**Waterfront Barry,
Vale of Glamorgan**

Stage 1 Road Safety
Audit

March 2010

Ove Arup & Partners Ltd

2.1 Waterfront Barry Link between Paget Road / Plymouth Road and West Pond / South Quay Junctions (TA Figure 7.7)

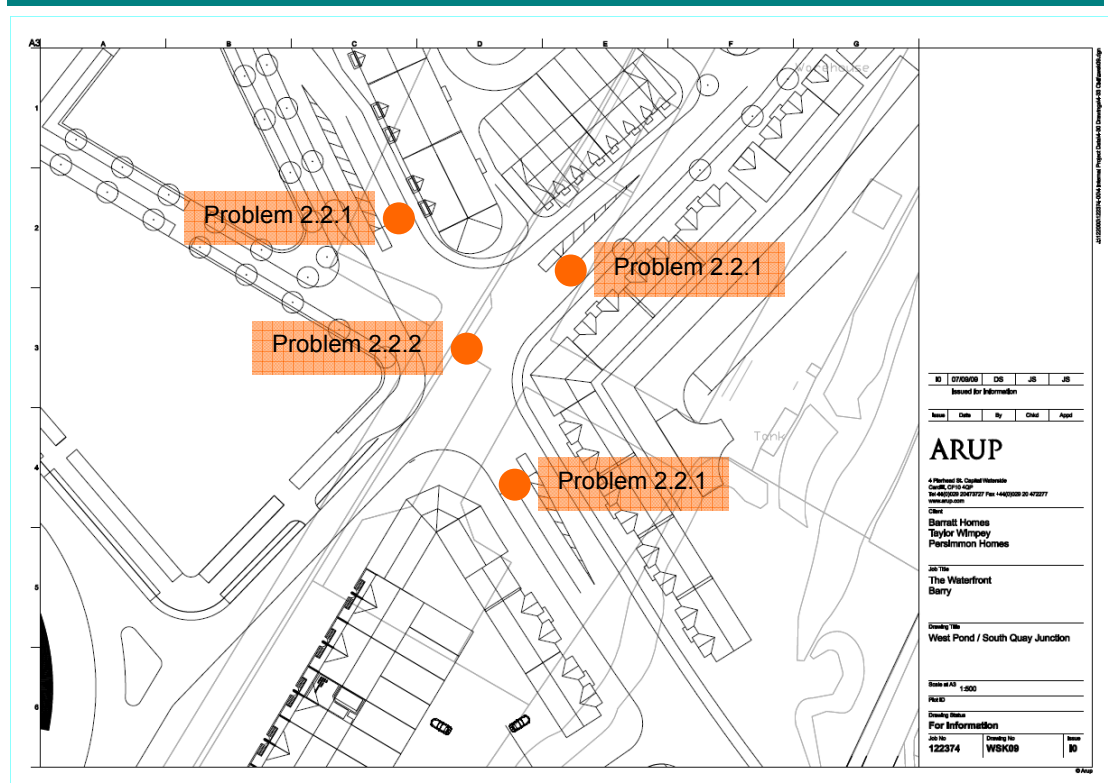
Description The Paget Road / Plymouth Road junction is significantly elevated above the existing dock area.

Steep grades can limit large vehicle's speed leading to frustration and overtaking conflicts.

Recommendation Ensure the grade does not exceed 6% (Waterfront Barry Link will be a bus route), and that vertical curves do not restrict the forward visibility of junctions.

**2.2 Waterfront Barry Link / West Pond / South Quay Junction
(TA Figure 7.7 Drawing WSK09)**

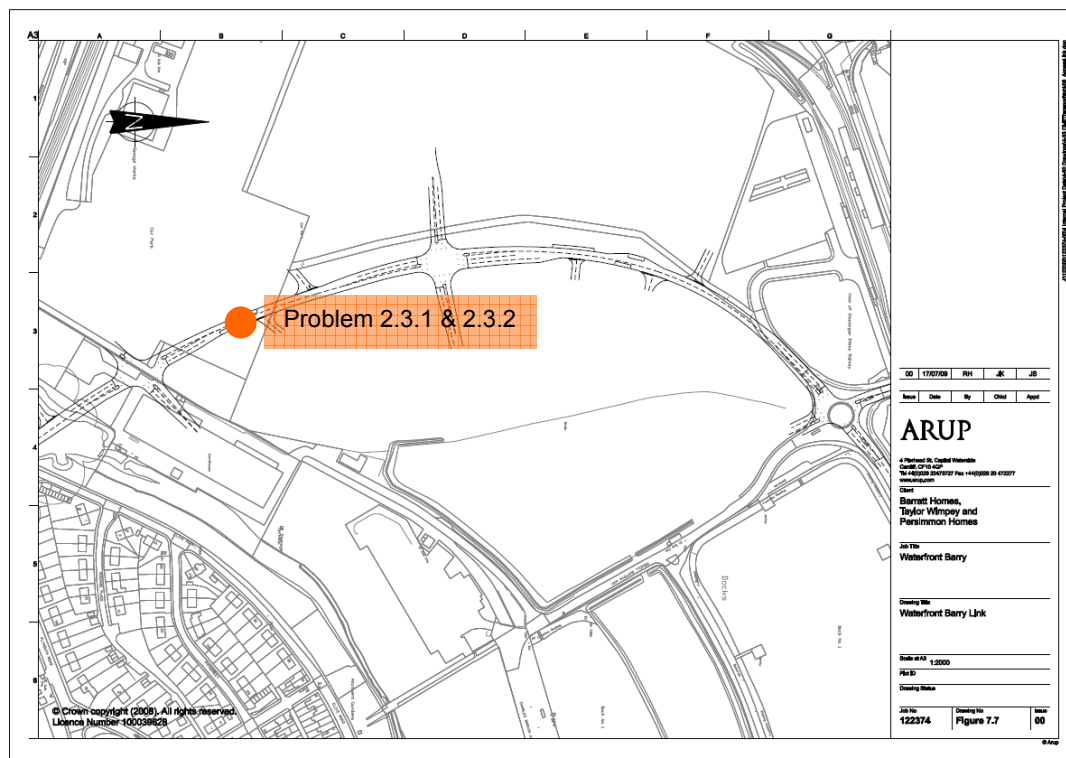
Description The stop lines at the proposed junction are set back a significant distance from the junction centre.

As a result there is a significant distance (approximately 60m) between opposing stop lines resulting in a large expanse of unmarked road surface. This is likely to result in large unused areas promoting the build up of detritus on the carriageway. In addition, some drivers may find the lack of direction here confusing leading to hesitancy.

Description The junction layout is such that it promotes an offside right-turning arrangement.

An off-side right-turning (hooking) arrangement can result in blocking during peak periods which can lead to driver frustration and side swipe accidents if vehicles are poorly positioned.

Recommendation Reduce the size of the junction.

Recommendation Provide additional road markings in the junction as appropriate to assist right turning drivers.

2.3 Waterfront Barry Link between West Pond / South Quay and West Pond / Supermarket junctions (TA Figure 7.7)

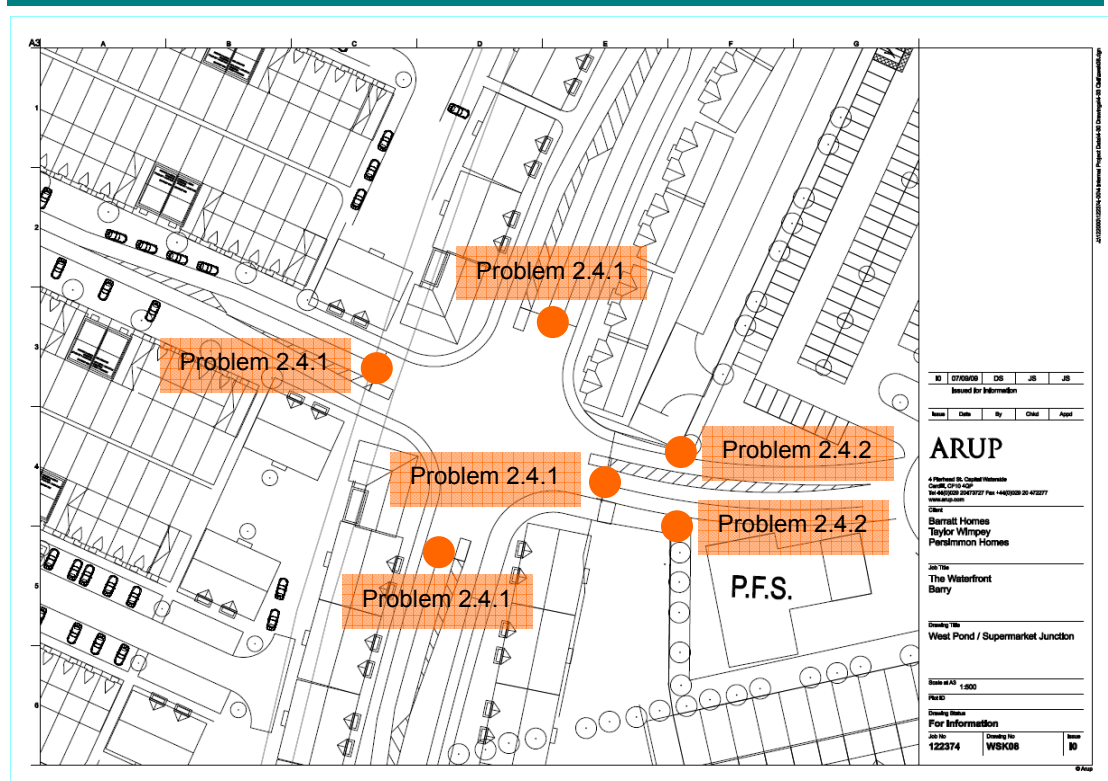
Description The eastbound and westbound bus stops on the southern section of the Waterfront Barry Link are located in close proximity to priority accesses serving residential properties.

The position of the southbound bus stop is within the junction visibility splay, which is likely to result in turning conflicts, whilst the northbound bus stop is located within the junction.

Description The eastbound and westbound bus stops provided on this section of the link road are located approximately 25 metres apart.

Insufficient space between bus stops can result in traffic congestion and passing conflicts.

Recommendation Relocate the bus stops away from the junction.

Recommendation Provide a minimum tail to tail offset of 40 metres to allow traffic to safely pass a stationary vehicle.

**2.4 Waterfront Barry Link / West Pond / Supermarket
(TA Figure 7.7 , Drawing WSK08)**

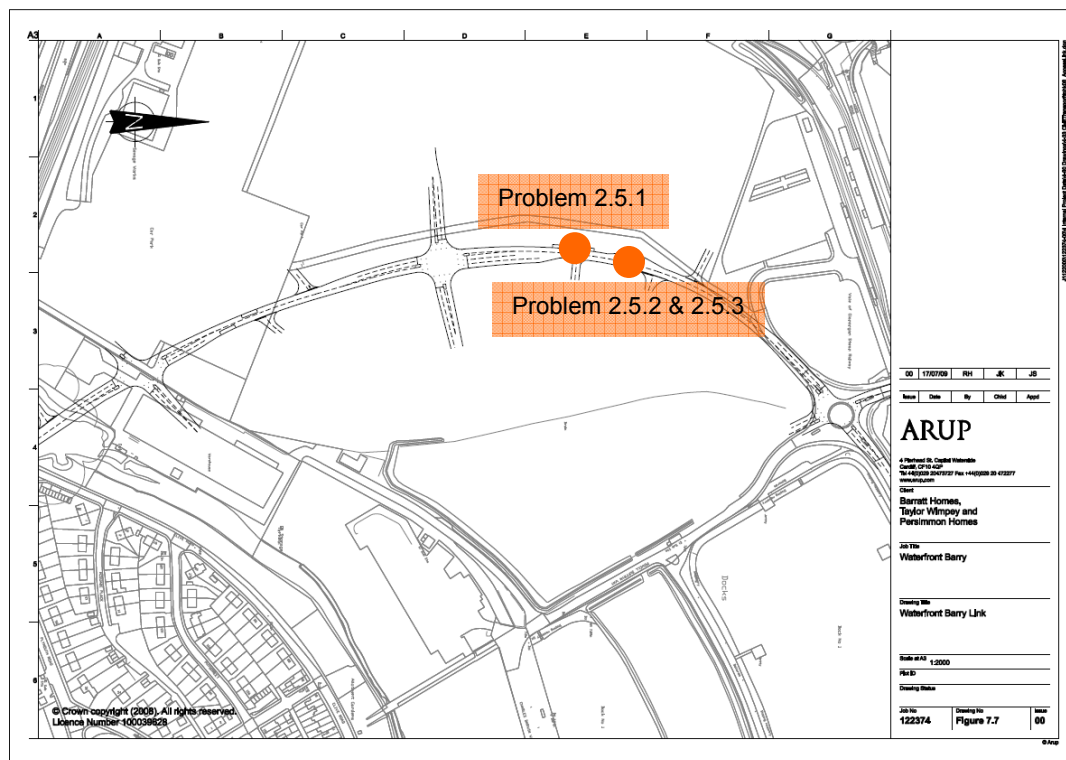
Description The stop lines at the proposed junction are set back a significant distance from the junction centre.

As a result there is a significant distance (approximately 50m) between opposing stop lines, resulting in a large expanse of unmarked road surface. This is likely to result in large unused areas promoting the build up of detritus on the carriageway. In addition, some drivers may find the lack of direction here confusing leading to hesitancy.

Description The proposals show footways on both side of the Supermarket access, however these stop after a short distance.

A lack of pedestrian access from the surrounding residential area will result in pedestrians either using the verge, risking slips and falls, or using the access road at the risk of a collision with a vehicle.

Recommendation Reduce the size of the junction.

Recommendation Ensure adequate intuitive footway links are provided to the supermarket.

2.5 Waterfront Barry Link between West Pond / Supermarket West Pond Northern junctions (TA Figure 7.7)

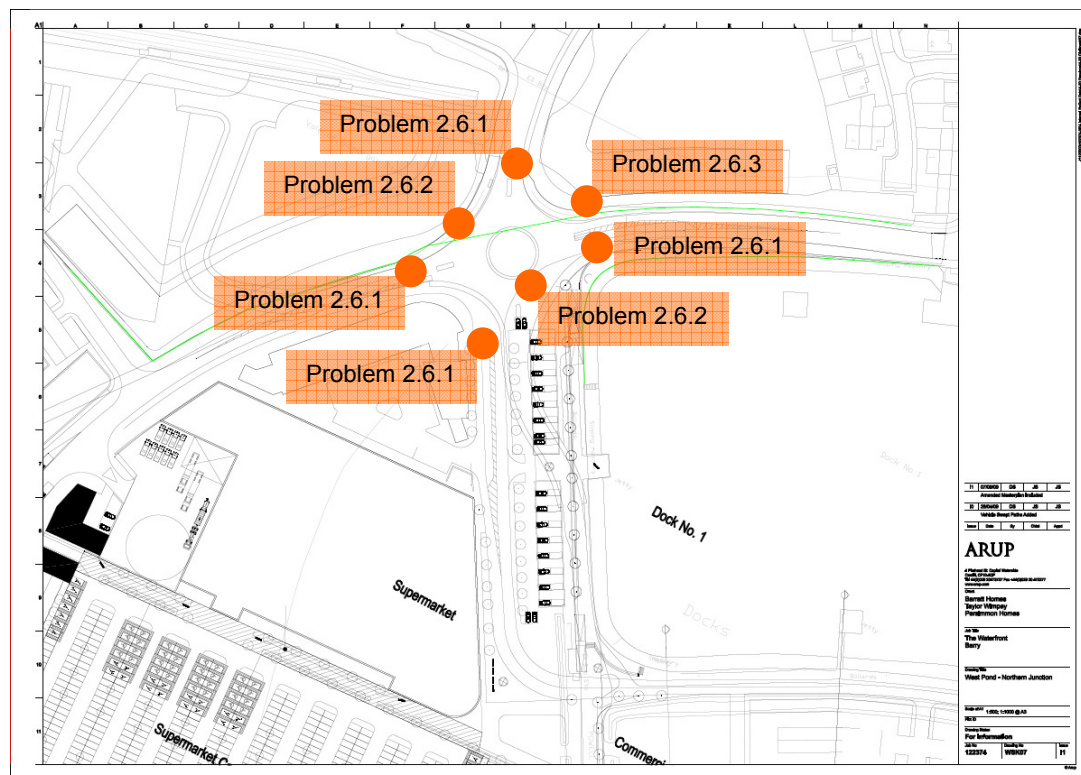
There is a group of kerbside parking bays opposite the junction to service residential properties on the northern section of the Waterfront Barry Link. The parking bays on the northbound carriageway introduce an additional conflict within the junction.

The bus stops on the northern section of the Waterfront Barry Link are located in close proximity to two priority accesses serving residential properties and the supermarket service yard. The position of the southbound bus stop is within the junction visibility splay, which is likely to result in turning conflicts. Whilst the northbound bus lay-by introduces an additional conflict within the junction.

Description The bus stops provided on this section of the link road are located opposite one another, rather than tail to tail.

This is likely to result in a high risk pedestrian crossing path behind and between the buses, placing pedestrians at risk of conflict with passing traffic.

Relocate the parking area away from the junction.

Relocate the bus stops away from the junction.

Recommendation Provide a minimum offset of 40 metres to allow traffic to safely pass a stationary vehicle.

**2.6 Waterfront Barry Link / West Pond Northern Junction
 (TA Figure 7.7 , Drawing WSK07)**

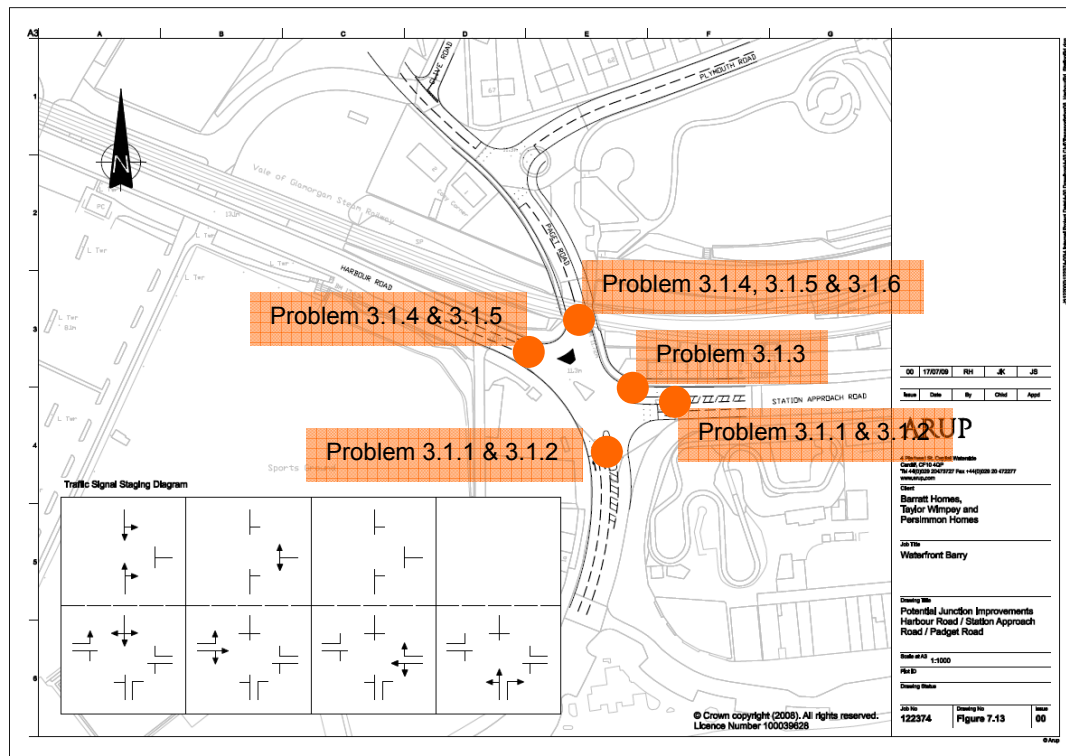
Description The stop lines at the proposed junction are set back a significant distance from the junction centre.

As a result there is a significant distance (approximately 70m) between opposing stop lines, resulting in a large expanse of unmarked road surface. This is likely to result in large unused areas promoting the build up of detritus on the carriageway. In addition, some drivers may find the lack of direction here confusing leading to hesitancy.

Description The junction has been provided with sweeping radii particularly in the north western and south-eastern corners.
 Sweeping radii can result in high entry speeds, leading to loss of control on the exit.

Description It is not clear from the proposed arrangement how National Cycle Route 88, currently running alongside the existing junction is to be accommodated.

Cyclists are particularly vulnerable to side swipes at junctions and could be struck while crossing at splitter islands not specifically designed to accommodate them.

Recommendation Reduce the size of the junction.

Recommendation Reduce the junction radii to reduce traffic speeds within the junction.

Recommendation Include measures to assist cycles at the junction.

3.1 Harbour Road / Station Approach / Paget Road (TA Junction 08 Figure 7.13)

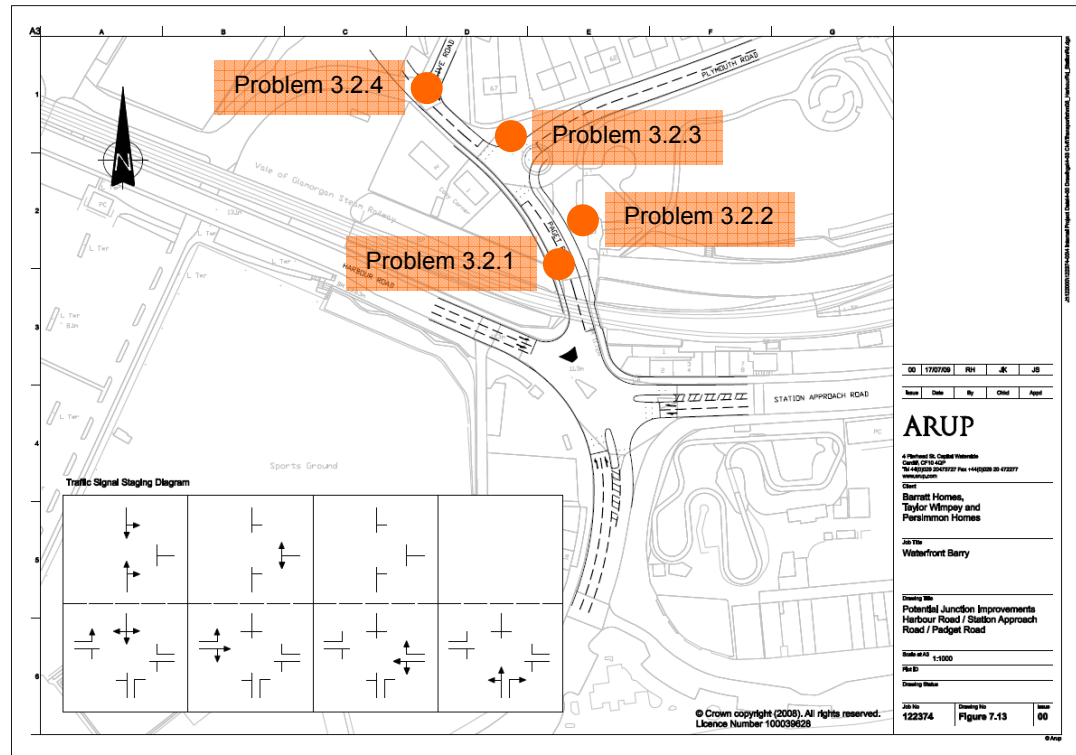
Description The crossings proposed on the southern and eastern arms of the junction have right-left staggers.

Description Due to the phasing of the junction, there will only be limited opportunity to cross the southern and eastern arms of the junction.

Description The exit arm on Station Approach has a narrow throat as a result of the proposed splitter island.

Description Pedestrian crossing facilities are not proposed on the northern or western sides of the junction.

Description The Paget Road arm of the junction runs under a railway bridge in the immediate vicinity of the junction. As a result drivers will emerge from the shadow of the bridge as they meet the traffic signals.

Description Paget Road is a bus route and buses currently struggle to turn from Harbour Road without encroaching on the southbound lane. The proposed kerb line will narrow the exit arm.

Recommendation Provide the crossings with a left-right stagger.

Recommendation Consider an all red crossing arrangement of this junction.

Recommendation Assess the junction using AutoTrack to ensure there is adequate carriageway width for large vehicles.

Recommendation Consider an all red crossing arrangement of this junction.

Recommendation Provide backing boards on the traffic signal heads in order to maximise visibility.

Ensure the lane markings provided on Paget Road can accommodate buses turning from Harbour Road.

3.2 Paget Road / Plymouth Road (TA Junction 22 Figure 7.13)

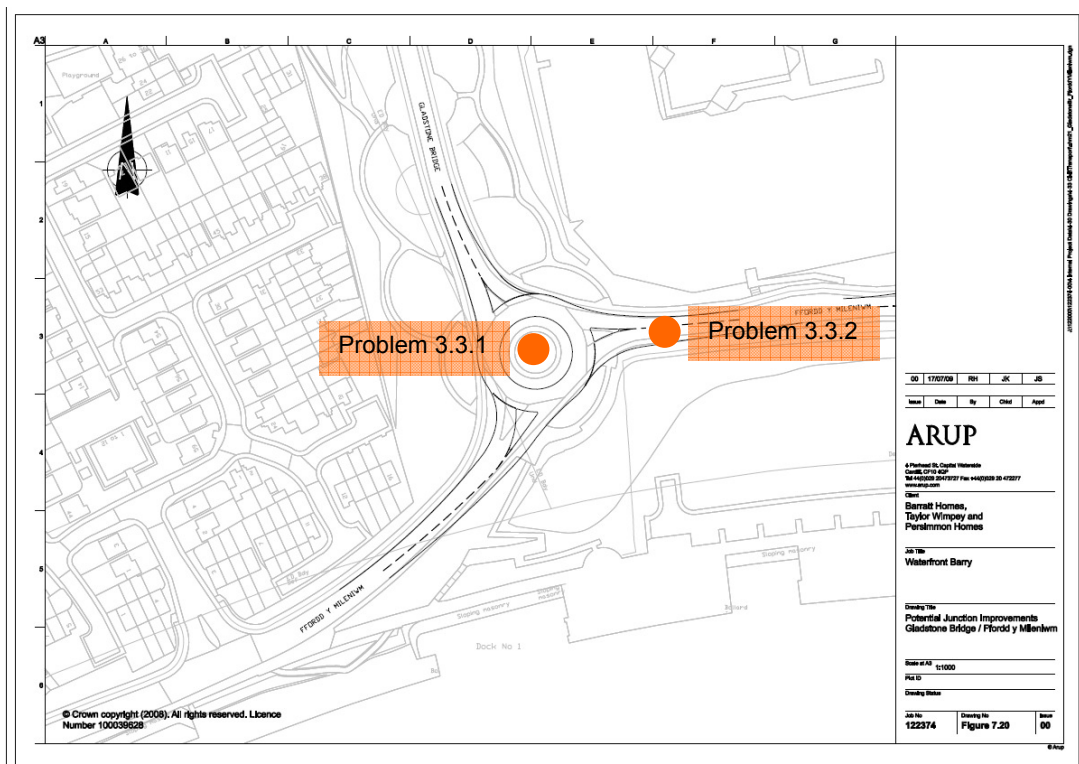
Road markings presently directing visitors to the car park are not shown on the proposed road layout.

The maintenance access to Maslin Park from Paget Road is not maintained in the proposed road layout.

There are several properties set around the junction area where, despite parking restrictions, kerbside parking occurs. It is proposed to enlarge the footway in this area which may be attractive for parking.

Clive Road has a steep grade, and the proposals introduce a priority junction at the foot of the grade.

Provide appropriate traffic signing and/or road markings to guide visitors to the car park.

Ensure adequate access is maintained for the park.

Introduce deterrent measures to prevent footway parking around the junction.

Provide speed reduction measures and high friction surfacing on the Clive Road approach to the Waterfront Barry Link

3.3 Gladstone Bridge / Ffordd y Mileniwm (TA Junction 21, Figure 7.20)

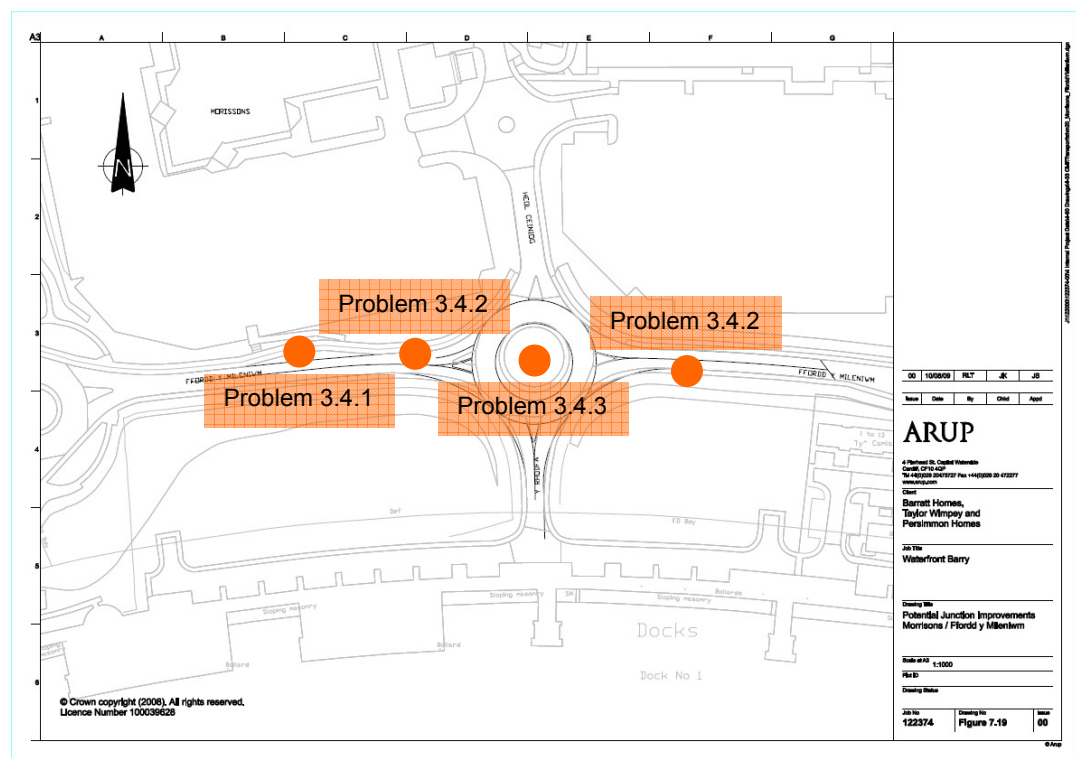
There is an excessive amount of vegetation and hard landscaping on the circulatory island of the roundabout

Description The proposed alteration to the junction layout results in an increase in the deflection radius of in the westbound approach of Ffordd y Mileniwm.

Recommendation Remove the vegetation and hard landscaping.

Recommendation Alter the junction layout in order to provide sufficient entry deflection.

3.4 Heol Ceiniog / Ffordd y Mileniwm (TA Junction 20, Figure 7.19)

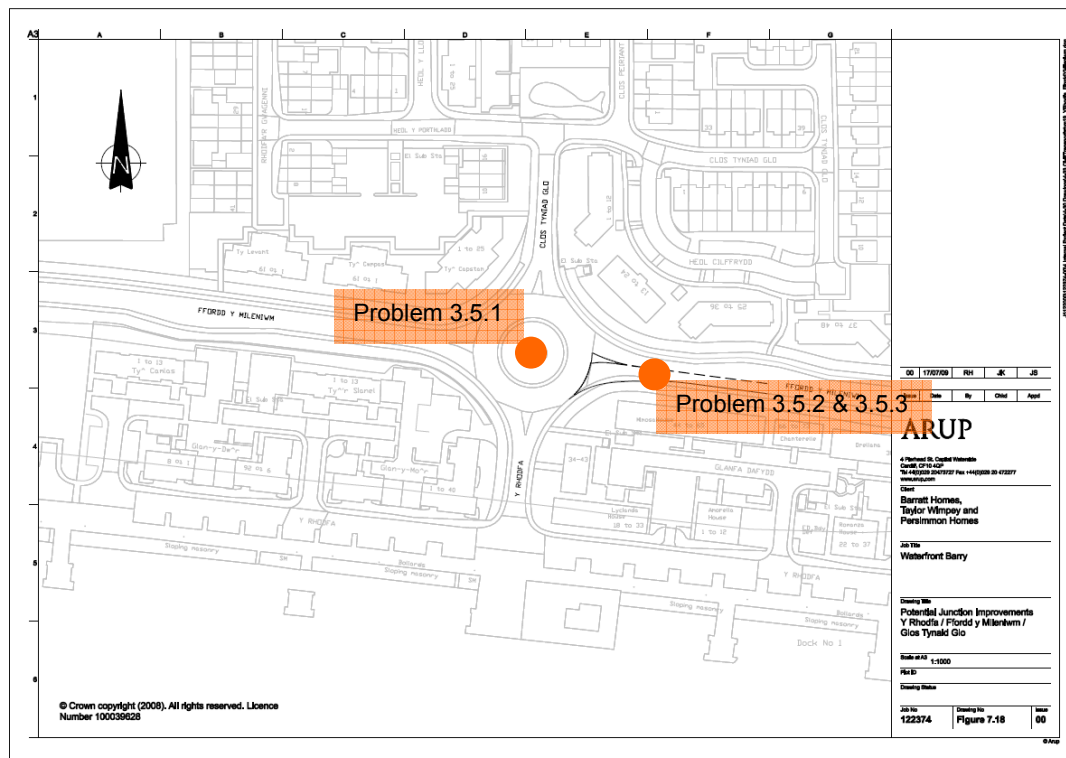
Description The proposals appear to show the removal of the existing bus stop lay-by on the north side of Ffordd y Mileniwm, adjacent to Morrison's supermarket.

The proposed alteration to the junction layout results in an increase in the deflection radius on the approaches to the junction, particularly Ffordd y Mileniwm

There is an excessive amount of vegetation and hard landscaping on the circulatory island of the roundabout

Retain the bus stop bay on Ffordd y Mileniwm.

Alter the junction layout in order to provide sufficient entry deflection.

Remove the vegetation and hard landscaping from the roundabout
